**Canterbury Earthquakes Royal Commission**  
**Te Komihana Rūwhenua a te Karauna**

**617-625 Colombo St**

**Canterbury Earthquakes Royal Commission: 617-625 Colombo Street, Christchurch**

**617-625 Colombo Street & 143 Tuam Street  
(Best Little Law House)  
Detailed Structural Evaluation**

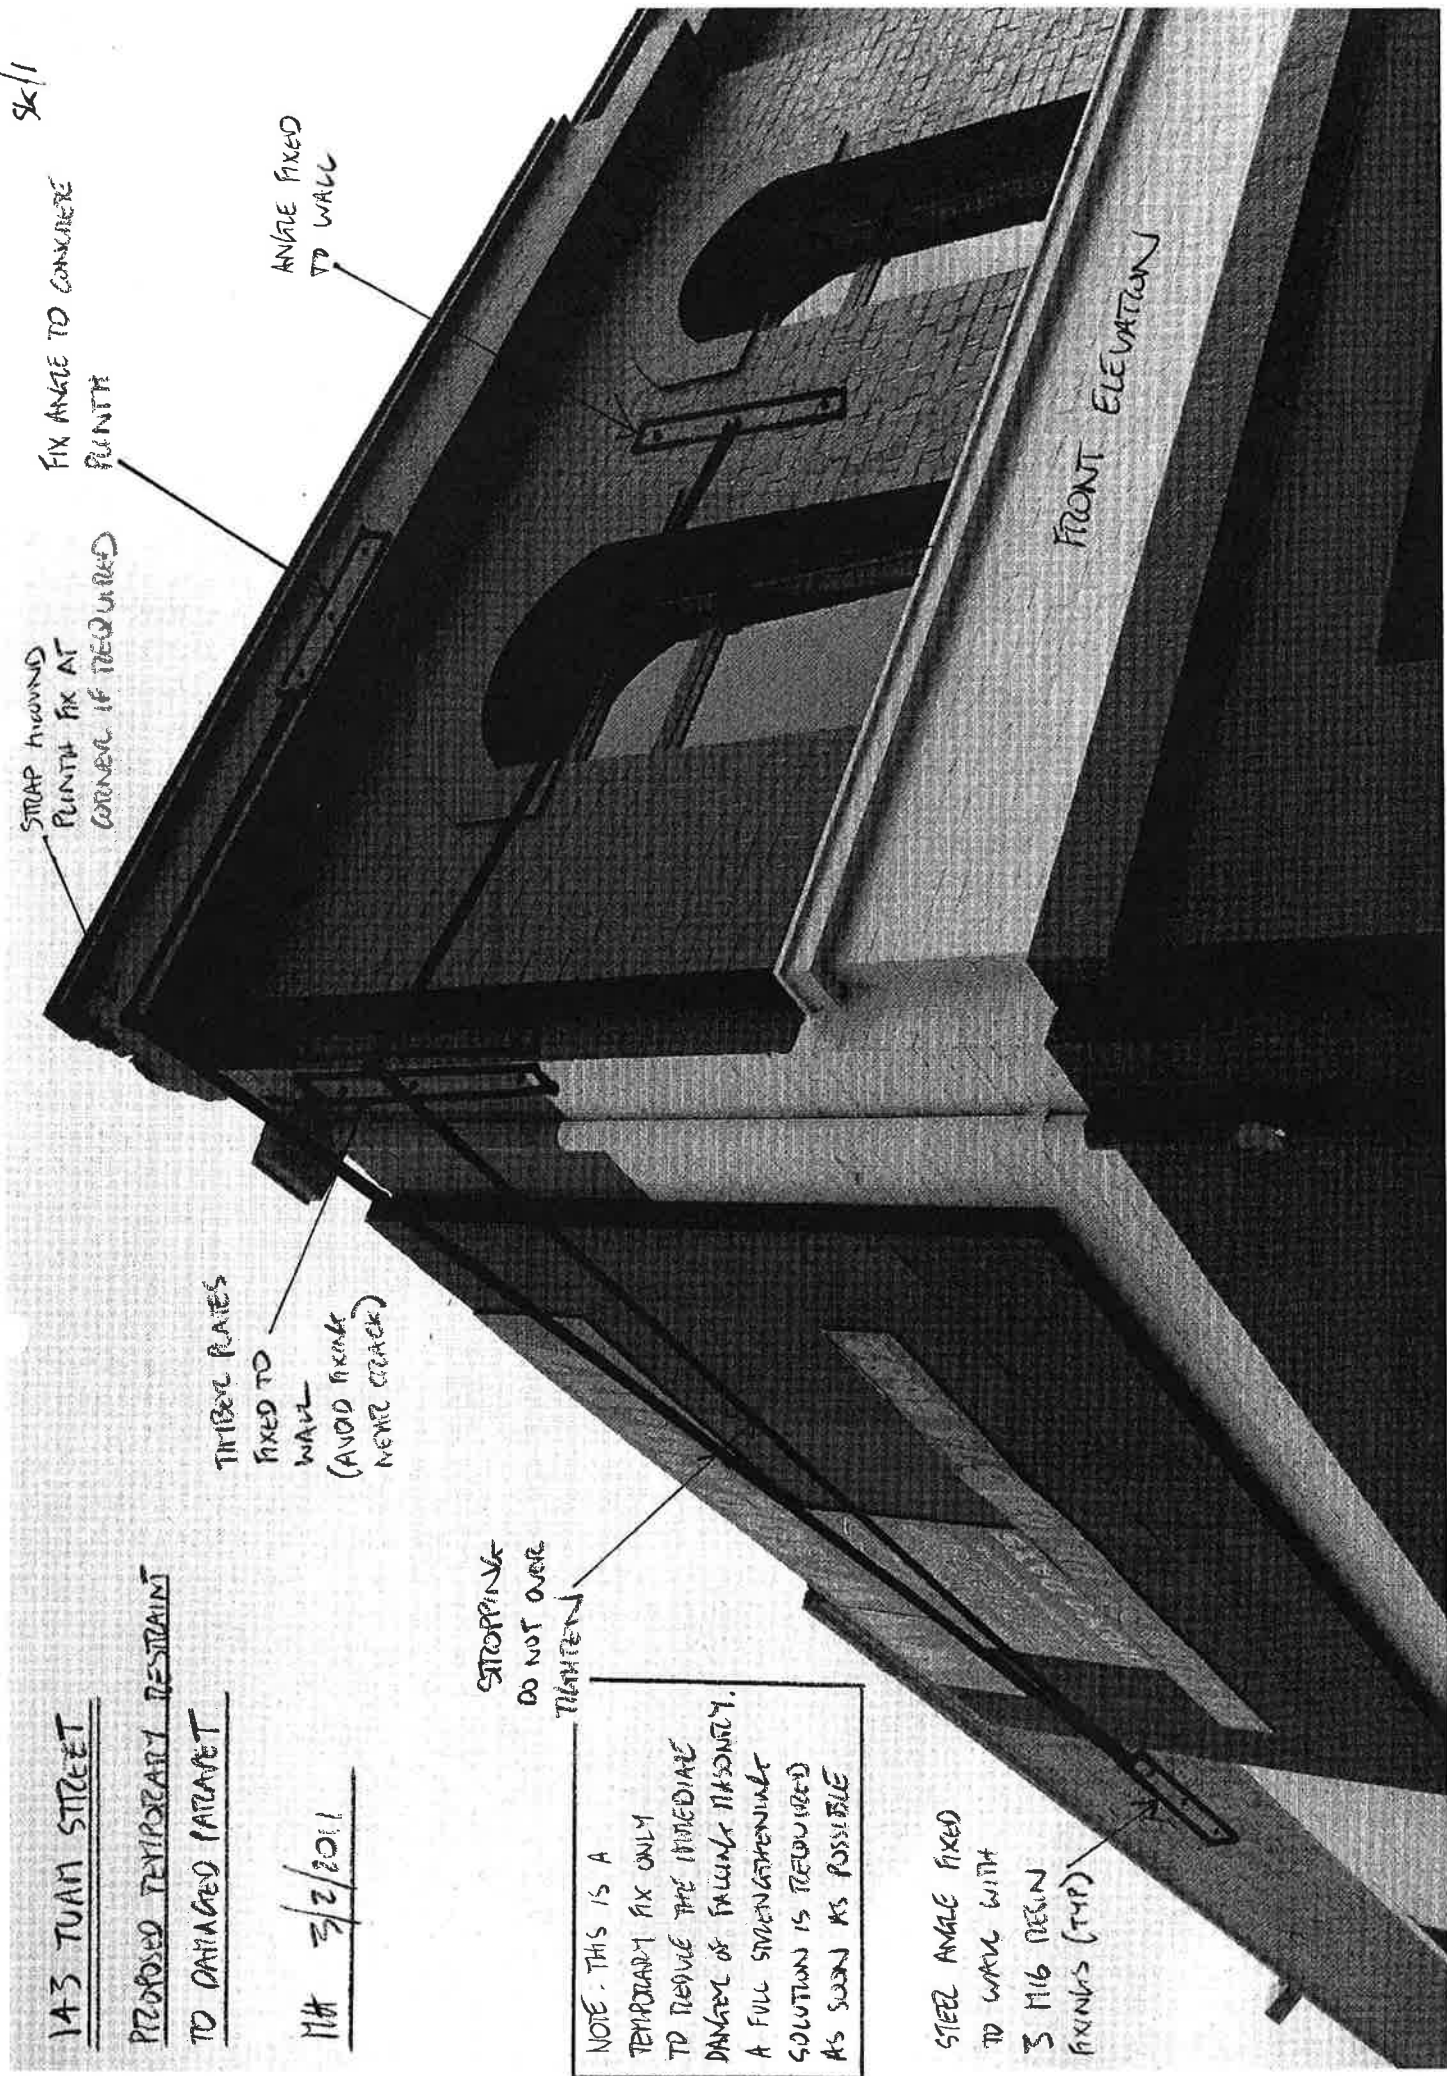
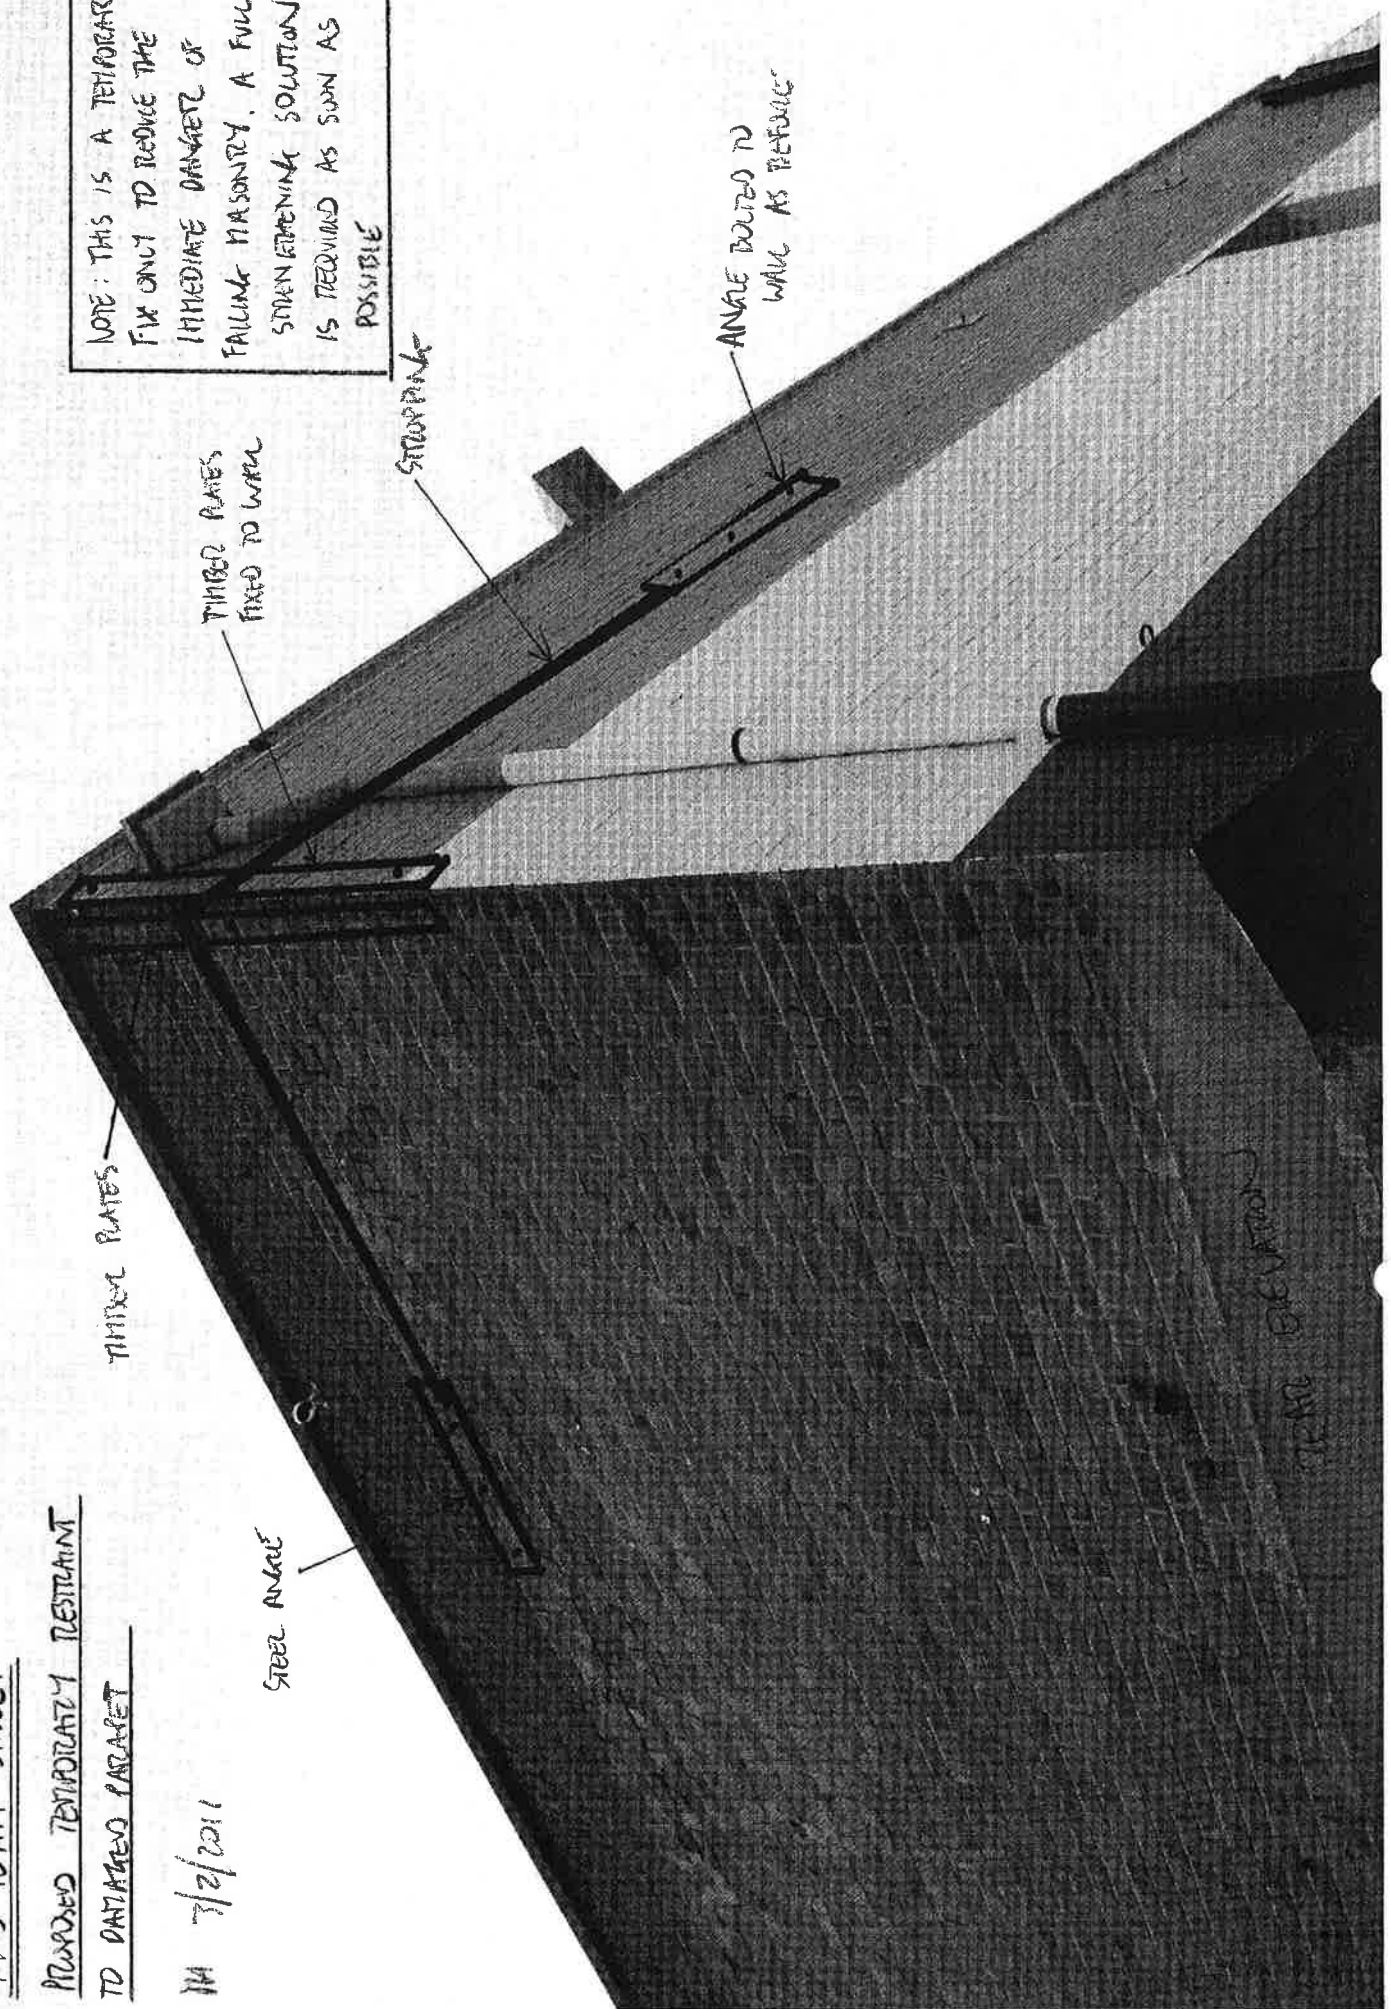
Refer attached parapet restraint sketch details dated 3 February 2011.

Immediately following the issue of the temporary parapet restraint details for 143 Tuam Street, we highlighted that this was a temporary safety measure and reiterated the need for a full building assessment and that a fully engineered solution for strengthening the external masonry (and the rest of the building structure) should be undertaken as soon as possible.

We also noted that attention should be given to stabilising the parapets of 143 Tuam Street for public safety purposes.

We possess photographic evidence the temporary restraint to the parapets of 143 Tuam Street was implemented – and proved effective in the 22 February earthquake. Refer attached photographs.

NOTE - THIS IS A  
TEMPORARY FIX ONLY  
TO REMOVE THE IMMEDIATE  
DANGER OF FALLING MASSIVENESS.  
A FULL STRUCTURAL ANALYSIS  
SOLUTION IS REQUIRED  
AS SOON AS POSSIBLE

NOTE: THIS IS A TEMPORARY  
FIX ONLY TO REDUCE THE  
IMMEDIATE DANGER OF  
FALLING MASONRY. A FULL  
STRENGTHENING SOLUTION  
IS REQUIRED AS SOON AS  
POSSIBLE
